# PEER REVIEW OF SACRAMENTO VALLEY FINITE ELEMENT GROUNDWATER MODEL (SACFEM)

U.S. Bureau of Reclamation

Prepared by:  WRIME

October 2011

Figure 16. Distribution of Deep Percolation Reduction Factors

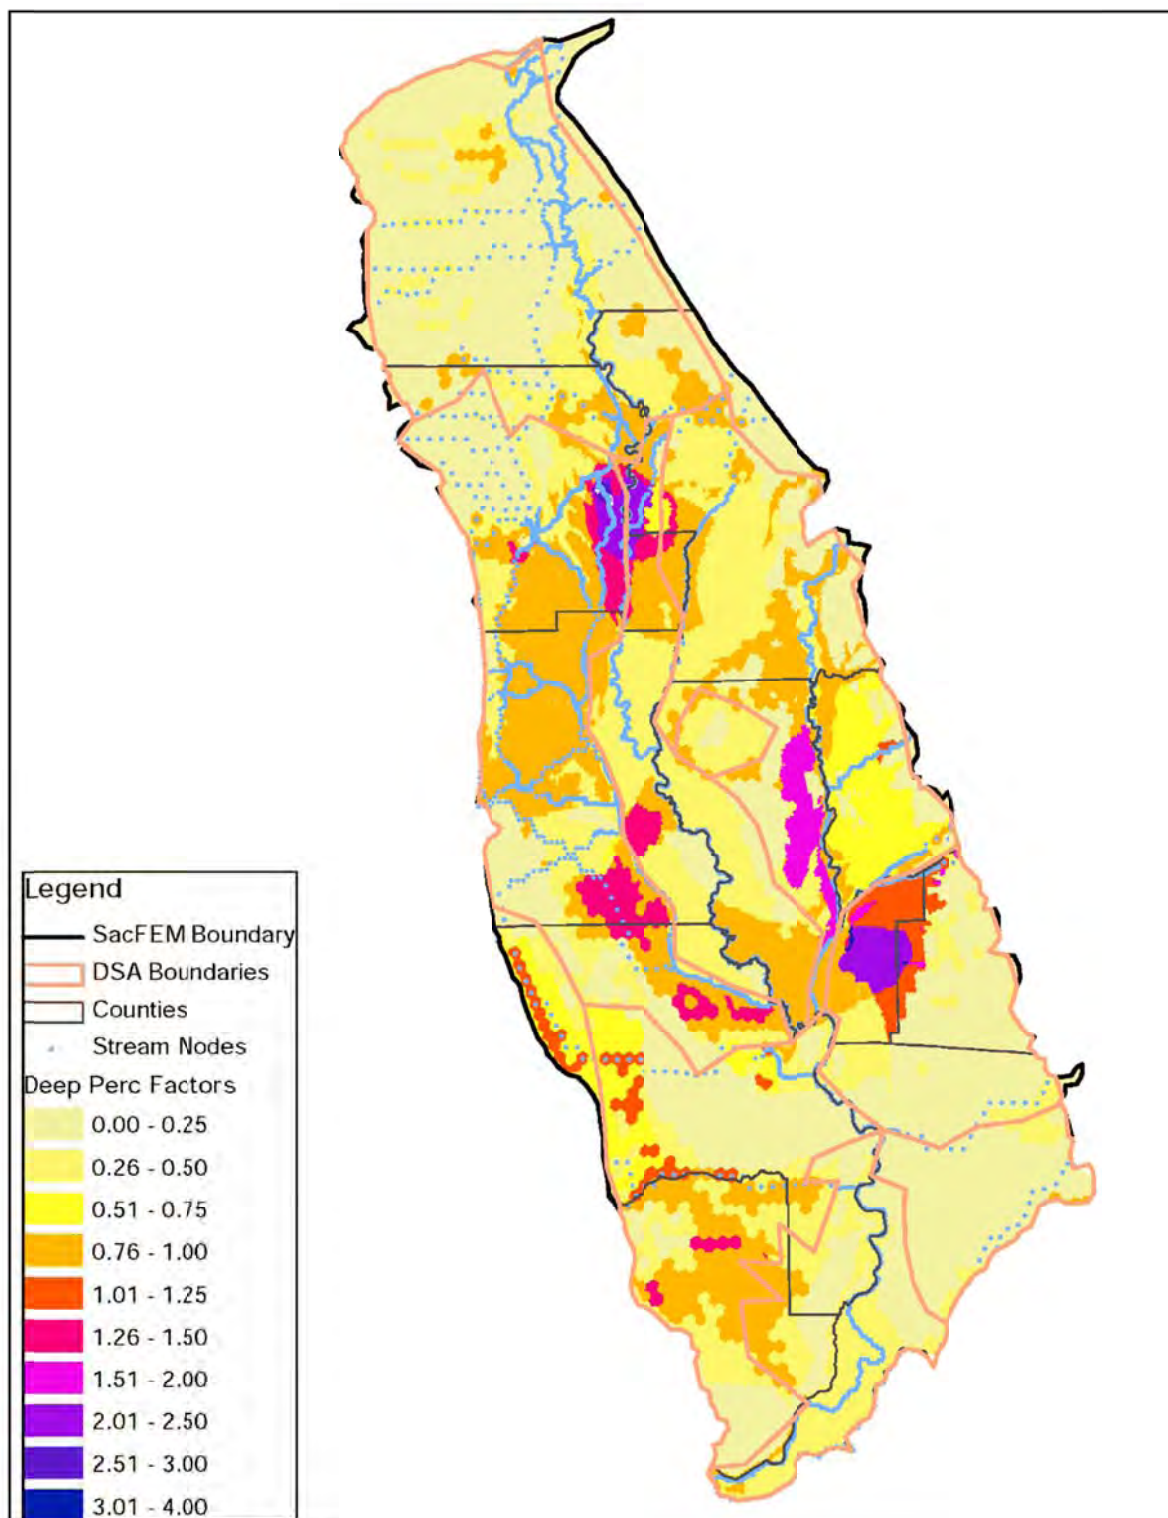
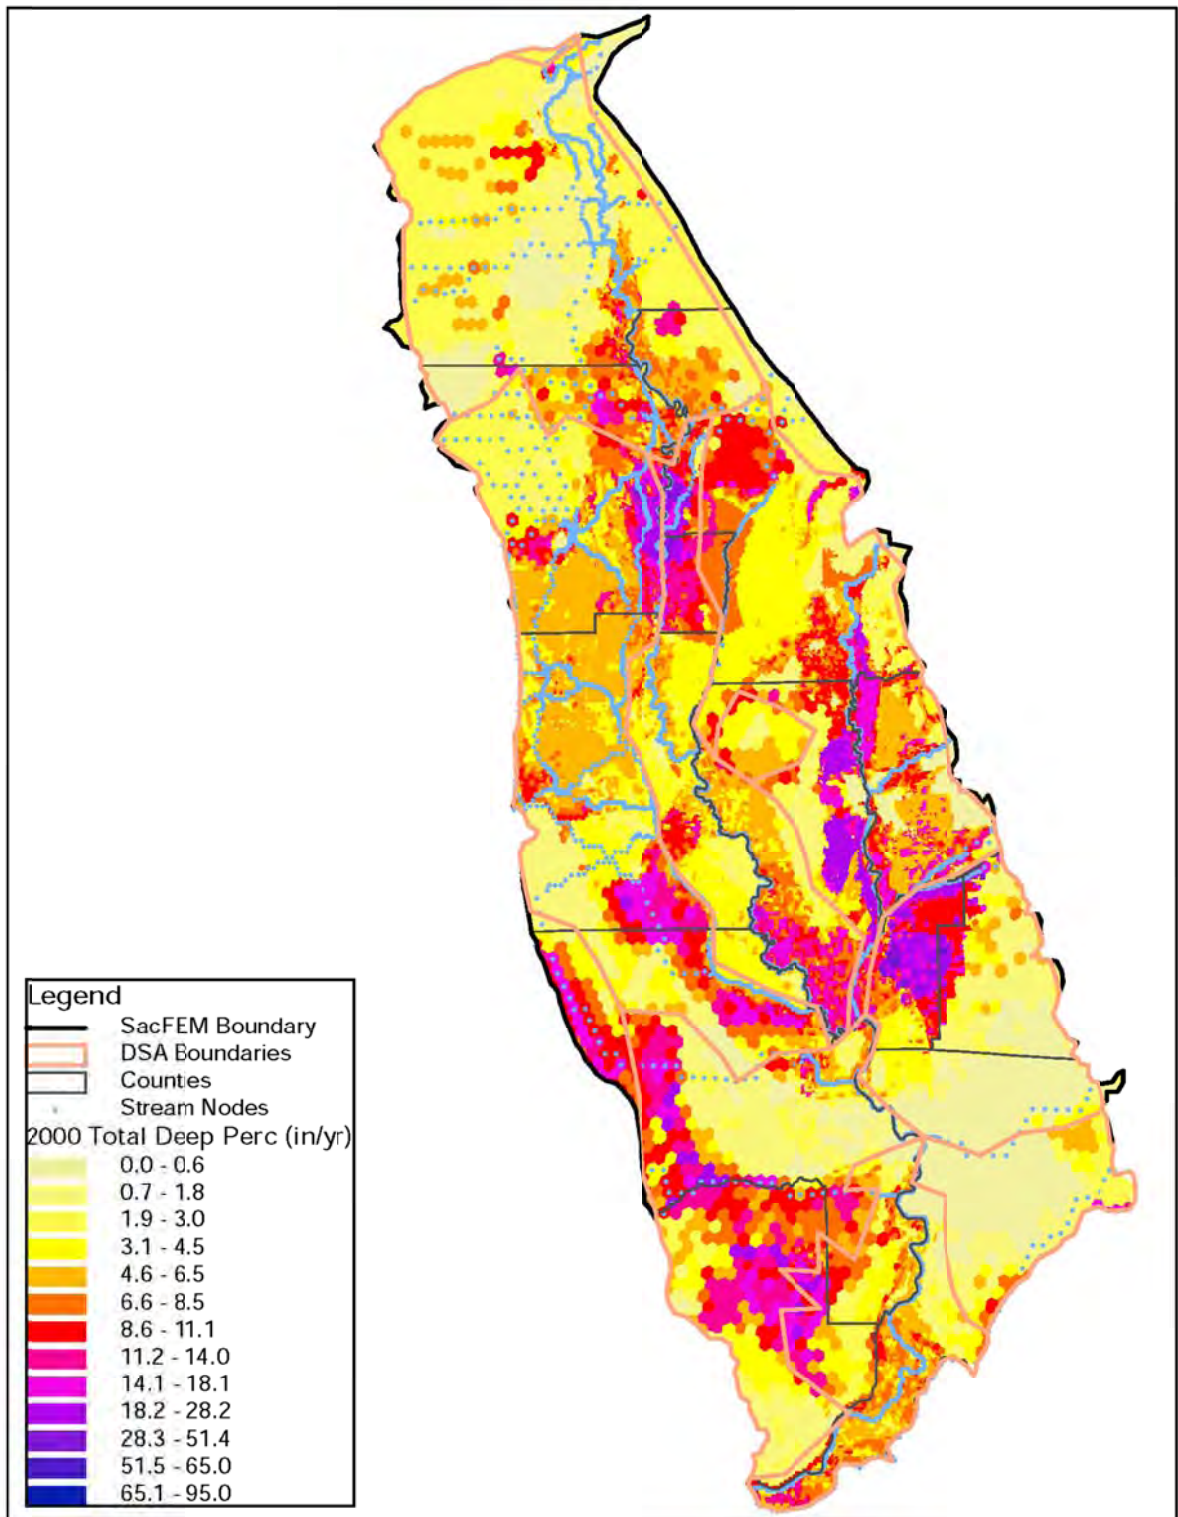
Because the IDC model deep percolation rates are significantly excessive, these rates were reduced for most parts of the model area before incorporating in SacFEM input data files. However, reduction factors are not uniformly distributed over the model area. High IDC deep percolation rates were further increased in specific areas before incorporating in SacFEM input data files. Annual deep percolation rates for the IDC model and SacFEM for the entire model area for 1970 to 2003 are shown in Figure 15. Average annual deep percolation volumes, rates, and reduction ratios factors by Depletion Study Areas (DSAs) are presented in Table 4. The distribution of deep percolation reduction factors is presented in Figure 16. The distribution of SacFEM total deep percolation rates is presented in Figure 17.

Reduction of the IDC model deep percolation rates in much of the model areas is reasonable; however, increasing deep percolation rates in specific areas results in significantly excessive deep percolation rates. More importantly, some of the excessive deep percolation areas correspond to project areas.

SacFEM final deep percolation rates are not supported by the fundamental IDC model methodology and parameters, resulting in a disconnect between the IDC model and SacFEM. It is recommended to incorporate a feedback loop between the IDC model and SacFEM deep percolation estimation with an appropriate convergence level between the two models (Figure 18). It is further recommended to make appropriate adjustments in the IDC model parameters on a monthly basis to develop revised deep percolation estimates for SacFEM. Because SacFEM deep percolation factors are not consistent with distribution of other data sets, it should be ensured that agricultural demand, groundwater pumping, and deep percolation estimates are supported by historical land use, crop mix, and agricultural practices.

Figure 21. SacFEM Total Annual Stream Gains/Losses

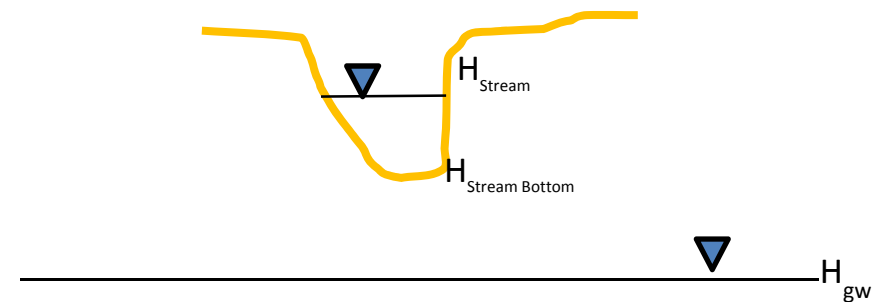
SacFEM stream gains and losses were compared to hydrological conditions of normal, dry and wet years. SacFEM total annual stream gains and losses for the entire model area are presented in Figure 21. SacFEM estimates higher stream losses in dry years such as 1976 and 1977, and lower stream losses in wet years such as 1983.

In the absence of stream stage data, adjustments of streambed resistances during the calibration process are used by some modeling efforts to fine tune the stream-aquifer interaction. However, for SacFEM the surface water stage fluctuations and groundwater level fluctuations are large enough to make a difference in stream gains and losses calculations and show that the assumption of constant stream stage is not valid. It is recommended that SacFEM use temporally varied stream stages on a monthly time step based on monthly streamflows. It is also recommended that the variable stream stages of regulated streams be revised for each SacFEM application scenario. Adjustment of streambed resistances may be used during SacFEM calibration after the stream stage data are incorporated in SacFEM input data files.

Figure 23. Net Stream Gain/Loss for Feather River at Oroville and Yuba City

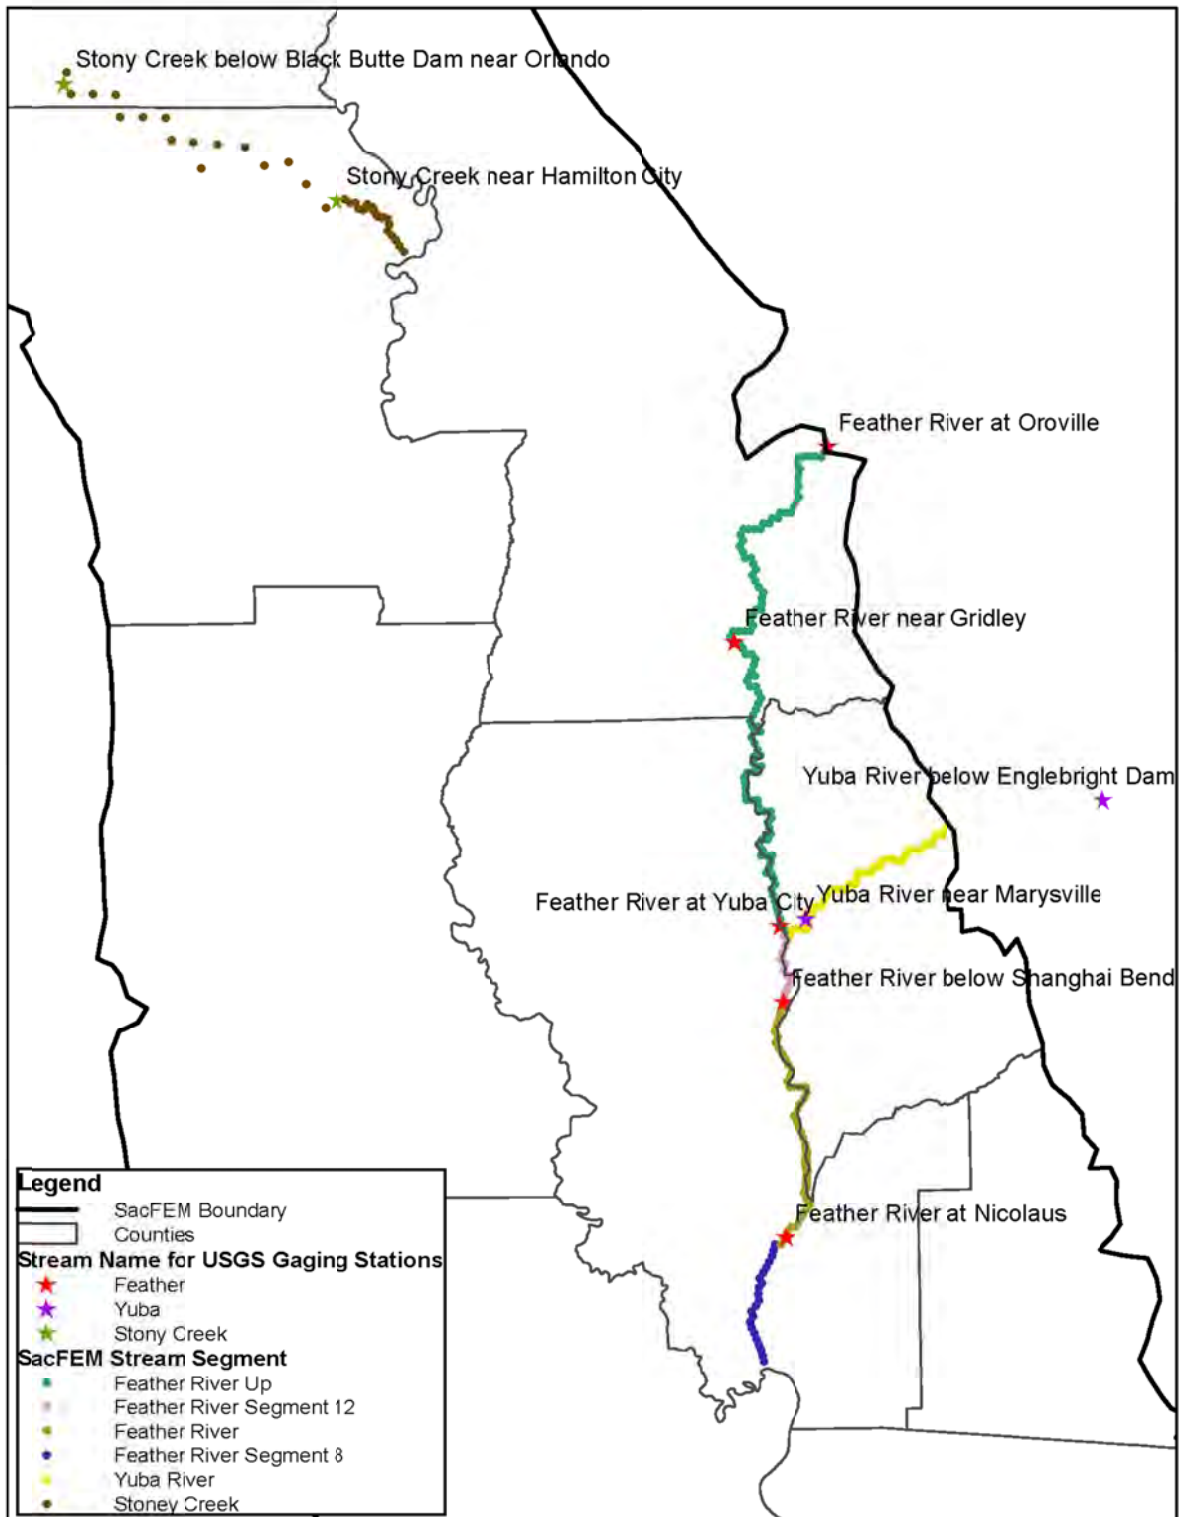
**Feather River** – A comparison of stream gains and loss estimates by SacFEM and the USGS study for Feather River at Oroville and Yuba City is presented in Figure 23. The USGS study shows this reach as a gaining and losing reach of Feather River; however, SacFEM consistently shows losses. SacFEM over estimates stream losses in the dry years of 1976 and 1977.

Figure 24. Net Stream Gain/Loss for Yuba River below Englebright Dam and Near Marysville

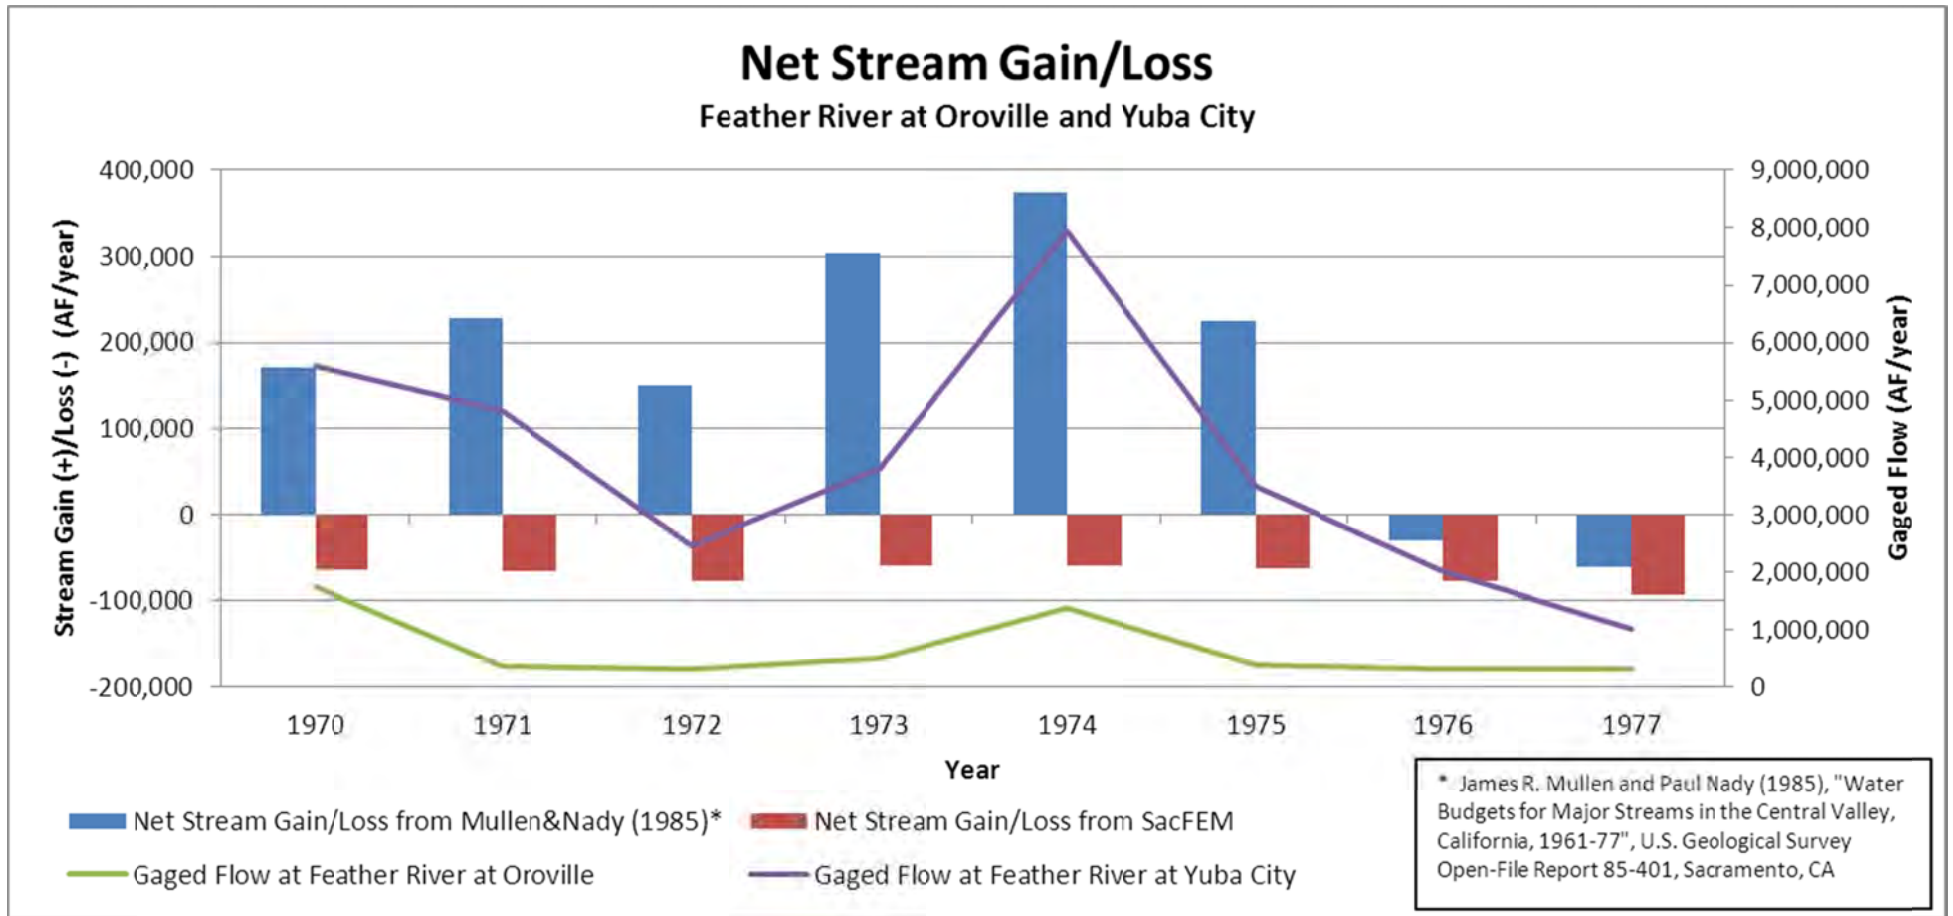
**Yuba River** – Stream gains and losses for Yuba River below Englebright Dam near Marysville are shown in Figure 24. The USGS study shows this reach as a gaining and losing reach; however, SacFEM shows losses consistently. SacFEM shows significant stream losses in 1977, while there were near zero flows in 1977.

Figure 25. Net Stream Gain/Loss for Feather River Below Shanghai Bend and at Nicolaus

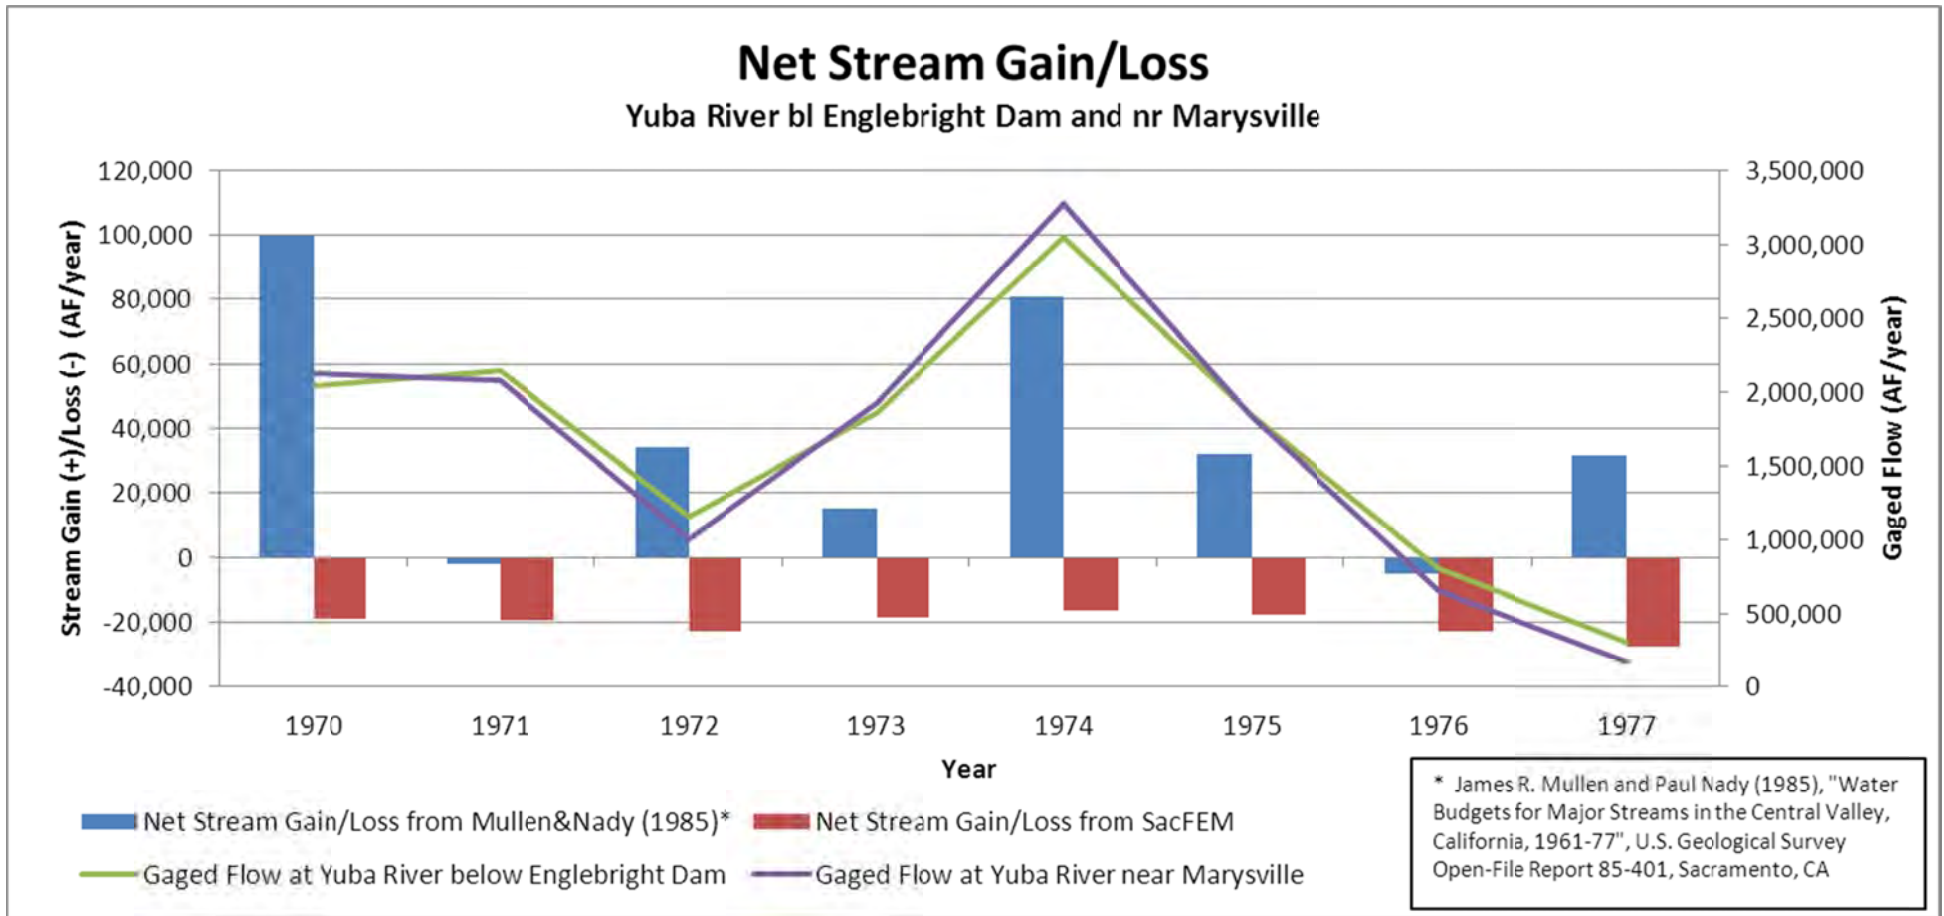
**Feather River** – Estimates of net stream gains and losses for Feather River below Shanghai Bend and at Nicolaus are provided in Figure 25. The USGS study estimates this section of Feather River as a gaining reach, while SacFEM consistently shows losses. SacFEM losses are overestimated in dry years.
